August 11, 2016

**Subject: Windsor Substation Project
Revision to Conceptual Landscape Plan**

**PG&E Arborist Assessment
Windsor Substation**

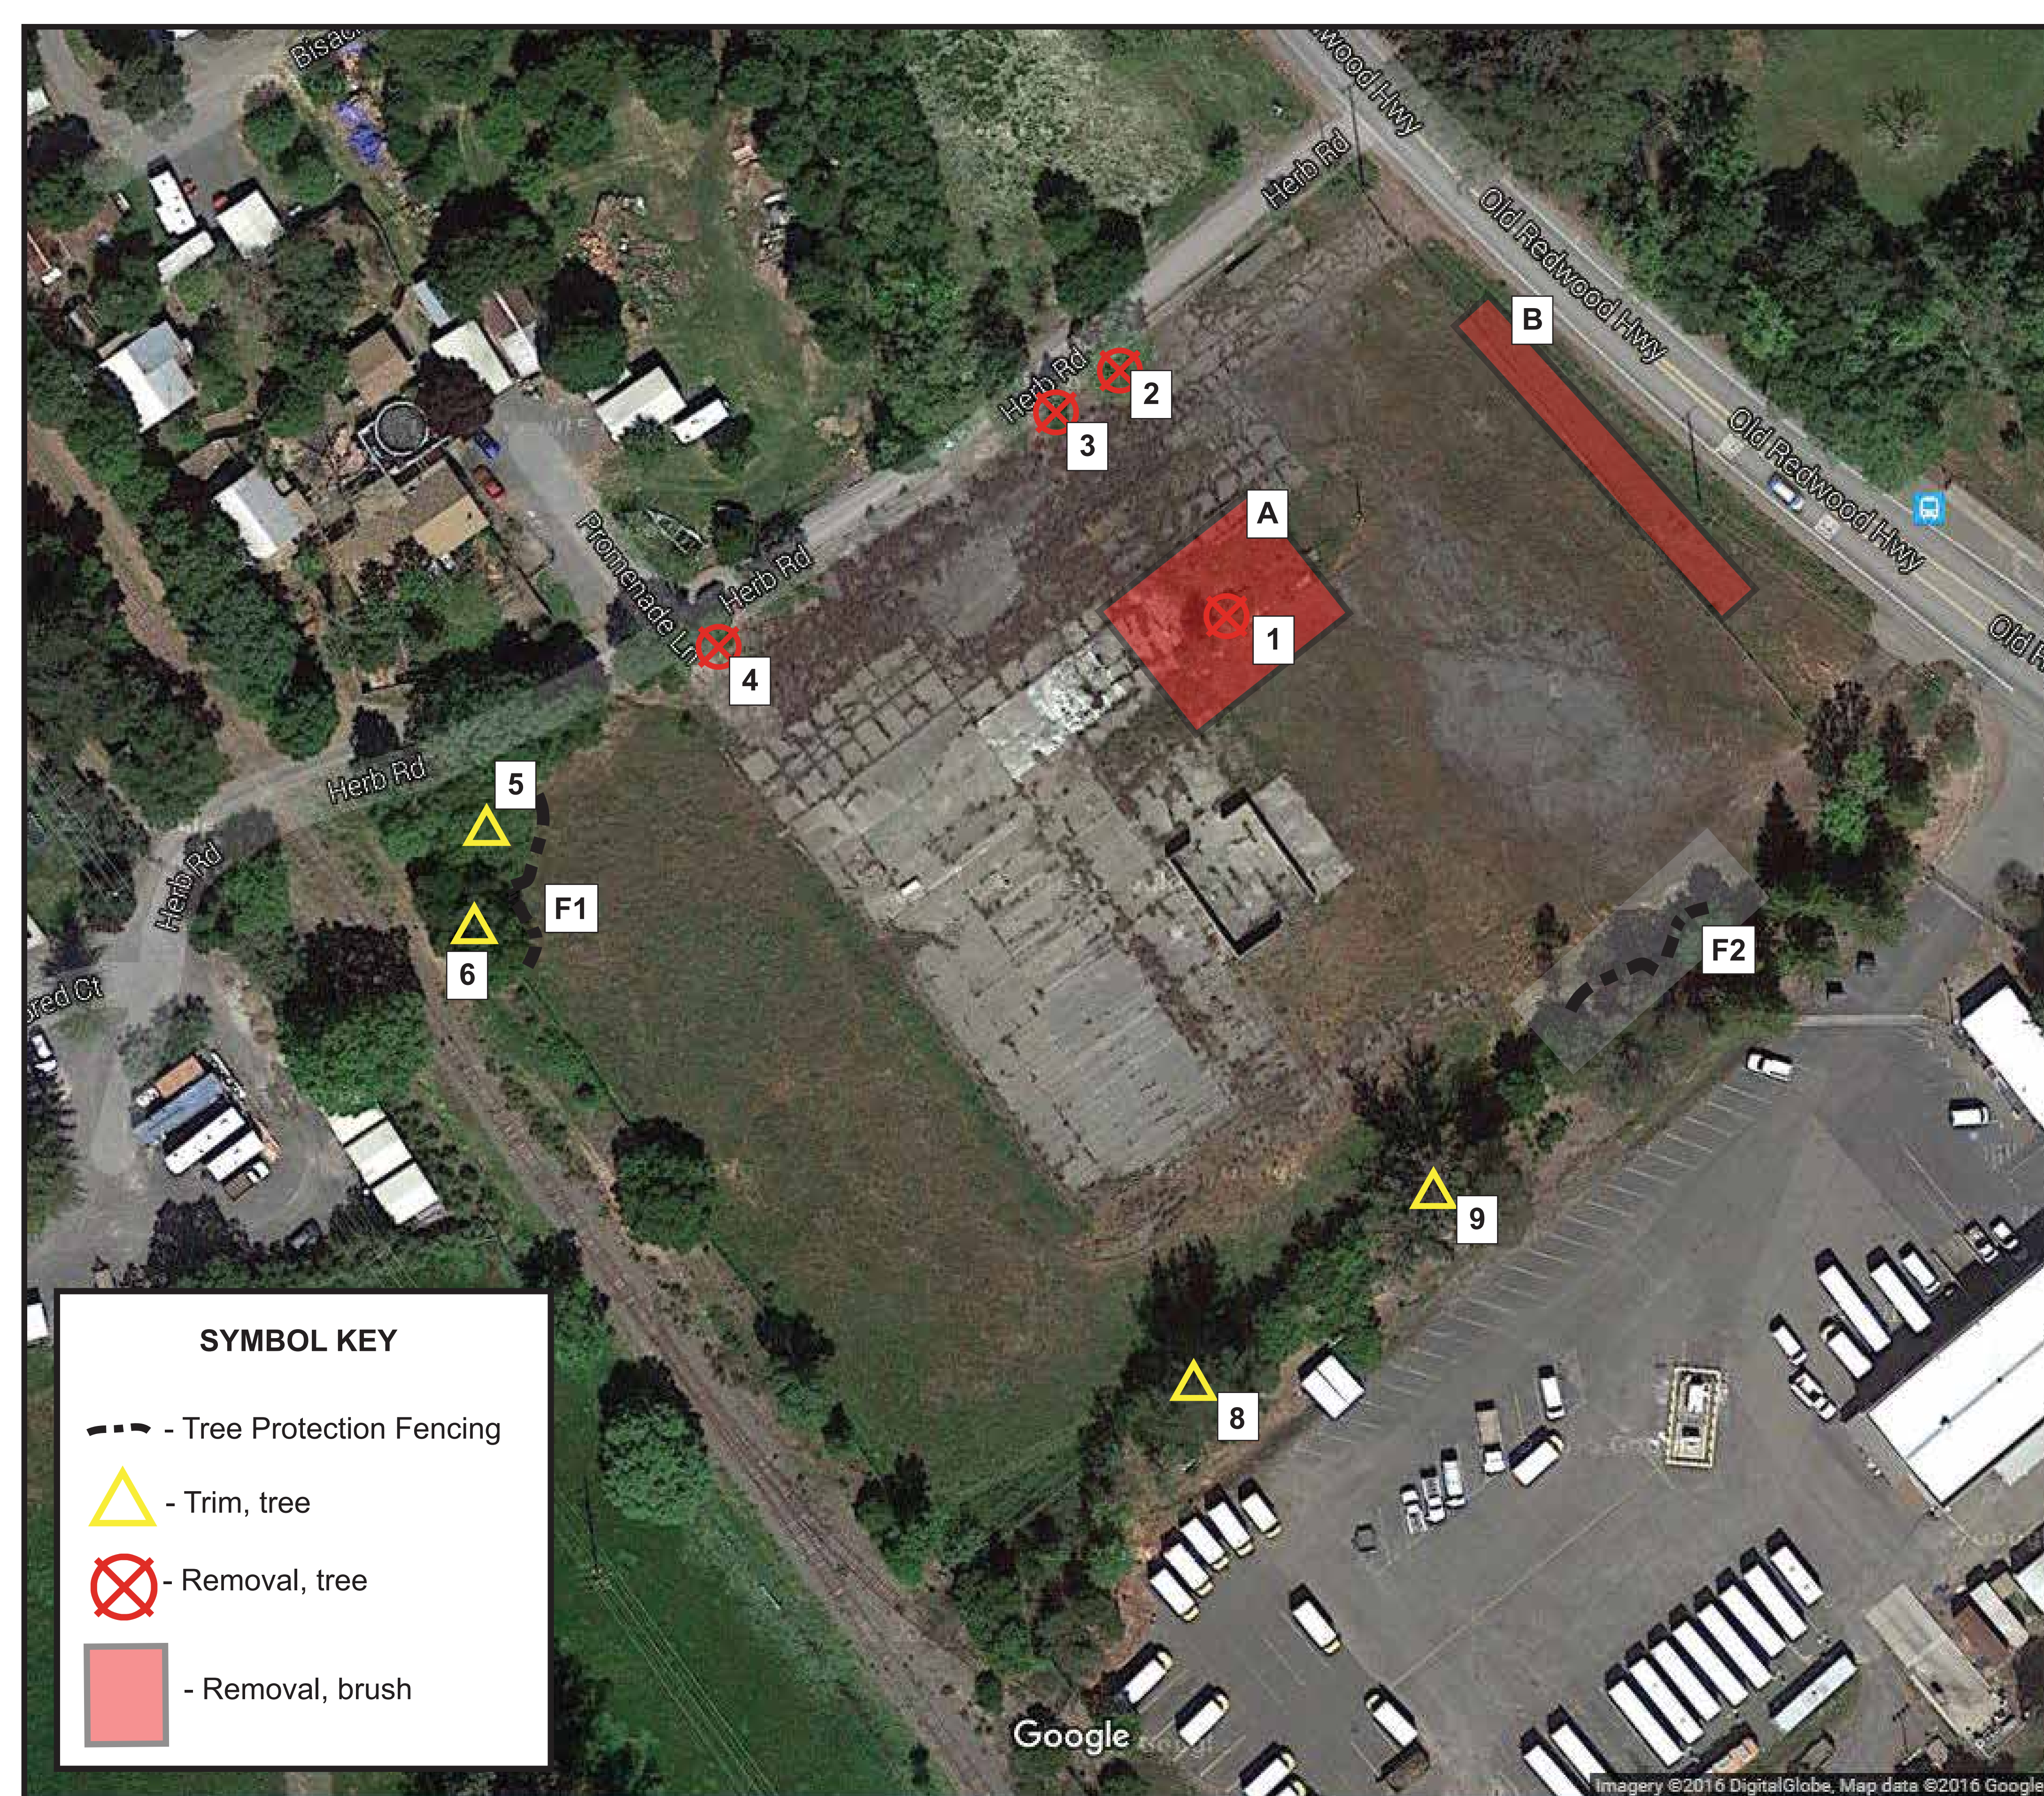
I am writing to update you on the latest revisions to the Conceptual Landscape Plan. We have completed the final engineering design at the substation, and the areas of ground disturbance have been further refined. An arborist review was conducted to confirm anticipated tree impacts. See Attachment A: PG&E Arborist Assessment. As shown in Attachment A, up to approximately four trees are proposed for removal at the substation site (tree numbers 1-4). Removal of these trees is recommended because, with completion of the final design and the grading plan, it was determined that ground disturbance and removal of existing concrete will adversely impact tree health and likely cause death.

Existing vegetation that lines the project site will be maintained on the south, west and north sides. To minimize impacts to existing vegetation and maintain tree health, tree trimming and protective fencing will be implemented as shown on Attachment A around trees that will be in close proximity to project activities. Additionally, existing vegetation will continue to be supplemented with implementation of the landscaping plan (See Attachment B: Conceptual Landscape Plan (Rev1)). The landscaping plan includes vegetation along the east, west and north sides of the project site.

TREE DESCRIPTION				
#	SPECIES	DBH	HT	PRESCRIPTION
1	Eucalyptus globulus	Ave. 6", Xstem	35'	Remove all re-sprouts and stump from previous Eucalyptus removal. Remove wood debris left by previous removal. Condition of tree- Good general health, bad structure.
2	Quercus lobata Valley Oak	24" 2 Xstem	32'	Remove tree in perimeter fence as concrete to be removed up to trunk of tree will negatively impact tree health and likely cause tree to die. Condition of tree- healthy.
3	Quercus agrifolia Coast Live Oak	27" 3 Xstem	18'	Remove all stems due to concrete in proximity to root system, tree will be damaged during excavation. Condition of tree- Tree not in good health. Middle stem is dead and rotted at base.
4	Quercus agrifolia Coast Live Oak	8"	12.5'	Remove tree in perimeter fence due to ground disturbance impact. Tree leans toward substation. Condition of tree- healthy.
5	Quercus agrifolia Coast Live Oak	54"	45'	Trim fence side limb for clearance and to eliminate overhang/future security risk. Overall canopy not to be reduced by more than 1/4 of the entire tree canopy. *Tree protection fencing required. Tree protection fencing shall be located a minimum 5' from the original drip-line of the canopy prior to trimming. Tree protection fencing can be moved for ease of construction as long as heavy equipment remains out of the area and risk for compaction is minimal.

6	Quercus agrifolia Coast Live Oak	24"	45'	Trim approximately two fence side limbs for clearance not to exceed a maximum 1/4 of the trees total canopy. Condition of tree- healthy.*Tree protection fencing required. Tree protection fencing shall be at least 2' from the drip line of the canopy prior to trimming. Tree protection fencing can be moved for ease of construction as long as heavy equipment remains out of the area and risk for compaction is minimal.
8	Pinus radiata Monterey Pine	70"	70'	Trim two overhanging limbs back to trunk for clearance. Condition of tree- healthy.
9	Eucalyptus camaldulensis Red Gum	80"	75'	Trim approximately 3 large overhanging limbs from the fence side. Condition of tree- Declining.

**Trees in this report have been assessed in relation to construction activity. An additional report is suggested to evaluate trees impacted by overhead conductors or facilities.
A	Brush, various	<4"	1-5'	Coast Live Oak brush, Coyote brush, blackberry and small palm tree to be removed and cleared. Including wood left from prior Eucalyptus removal.
B	Brush, various	<4"	1-5'	Oak brush to be removed and cleared.
F1 F2	Tree Protection Fencing			*Tree protection fencing required. Tree protection fencing shall be at least 5-2' from the drip line of the canopy prior to trimming. Tree protection fencing can be moved for ease of construction as long as heavy equipment remains out of the area and risk for compaction is minimal.
